20 January 2010
109 -165 Kimta Road
Victoria, BC V9A 7P1

Mr Andrew Whale
Crown Land Adjudication
Integrated Land Management Bureau
Suite 142, 2080 Labieux Road
Nanaimo, BC V9T 6J9

Re: File #1405848 (Victoria International Marina)

Fig. 2. Plot of the Minimum and Maximum daily tides predicted for 2010. The grade level of the walkway (2.41 m geodetic) would be at 3.75 m above MLLH at the corner

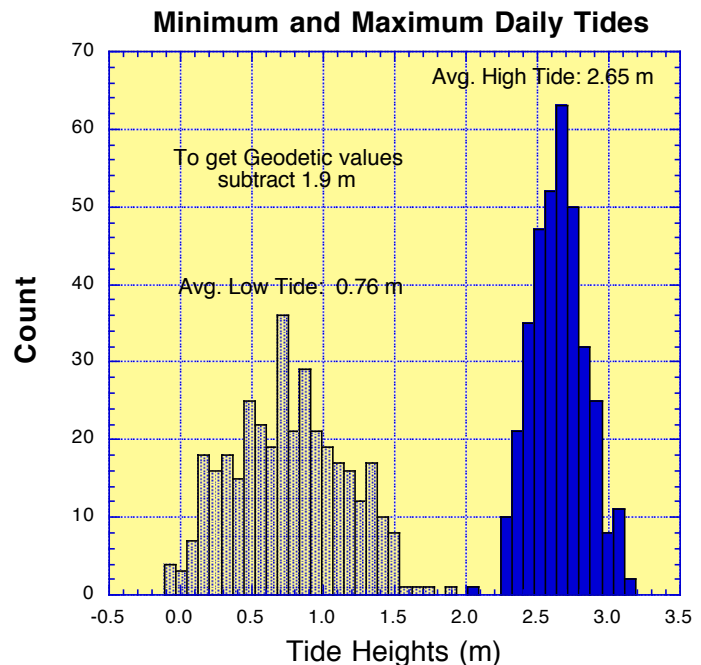
The plot of high tides in Fig. 1 shows that the highest tides are 3.2 m. Transport Canada has requested that the building platform be raised by 2 ft (0.6 m). The walkway slopes down by 0.8 m from the east part of the platform (3.2 m geodetic) to its west corner (2.41 m geodetic). The effect of this

(see Fig. 2) would be to raise the BOTTOM of the platform to a few inches ABOVE the stanchions (1.07 m tall) at the corner of the walkway. The 'inserted' stanchions show water levels for the actual tide of 2.68 m on Nov 20 (close to the average high tide) and the highest tide of 3.2 m. Clearance with a raised structure for the average tide would be about 7 ft (2.1 m) and 1.6 m at the highest tides.

Raising the level of the platform is necessary to give adequate headroom for paddlers, but a 4-5 ft gap above the walkway surface poses its own safety concerns and it is not clear that such a solution would get past city planning requirements. The photo itself shows why there is so much opposition to the marina. The park-like aspect of the walkway is completely destroyed by the presence of the marina.

Fig. 4. ASL Significant Wave Height distributions for 30 knot winds without (left) and with (right) the attenuator. The right hand distributions are the differences in SWH.

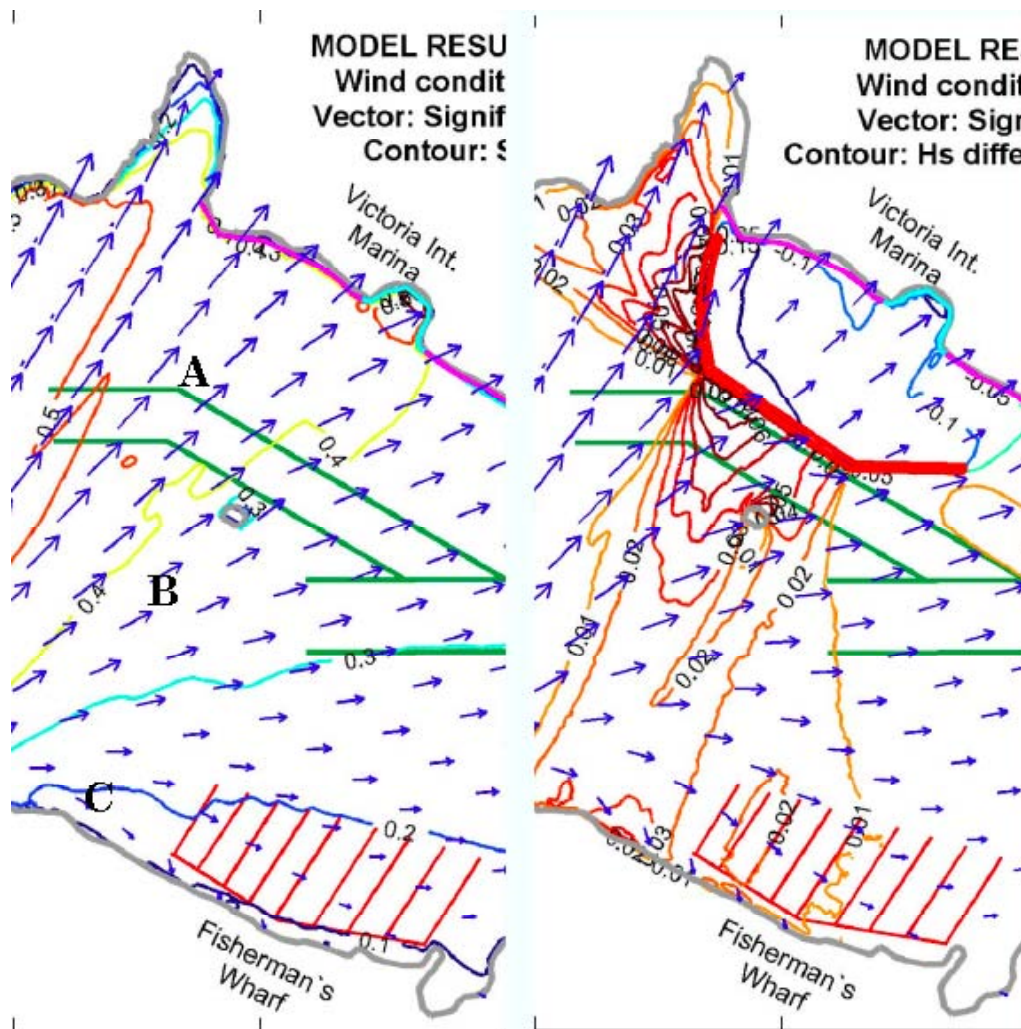
Dr Nico Booij, one of the developers of the SWAN program used by ASL for the calculations, stated in a communication to me that the SWHs of the two (incident and reflected) wave trains are effectively added in quadrature. This concept allows one to use the ASL results to estimate the SWH of the reflected waves. For example, using the 30 knot results for a sample calculation (see fig. 4)

MY estimate of the increase in the chop height in the runway area is 40% (ratio of the initial and reflected SWH values for point B in the sequence), not the typically < 10% given in the ASL report. This uses the calculated SWH with and without the attenuator in the ASL document.

I would like to point out apparent defects in the ASL calculations.

A simple glance at the reflected wave pattern in Fig. 4 shows that there are difficulties in matching the shape of the attenuator walls to the grid used in the calculation. This is seen in the wavy pattern of the reflections on the west-facing wall on the left part of the attenuator. It is not a physically realistic pattern. Technically, a similar pattern should have appeared on the east wall as well. Of a more serious consideration, it appears that there is little reflected wave energy from any part of the east half of the marina – 7 cm SWH reflected at the left end vs 2-3 cm at the right end. Almost all the reflected energy appears to come from the part west of Pelly Island. However the input wave pattern only shows a small decrease in wave height due to shadowing by Pelly Island and the wave energy incident along the main wall should only vary only by about 25% based on the input SWH values. Using the 50 knot example, it is unreasonable that the SWH reflection at the east part of the wall is just 1 cm while it is 13 cm from the west side. In fact the reflected wave appears bigger at Laurel Point than it does at the marina itself.
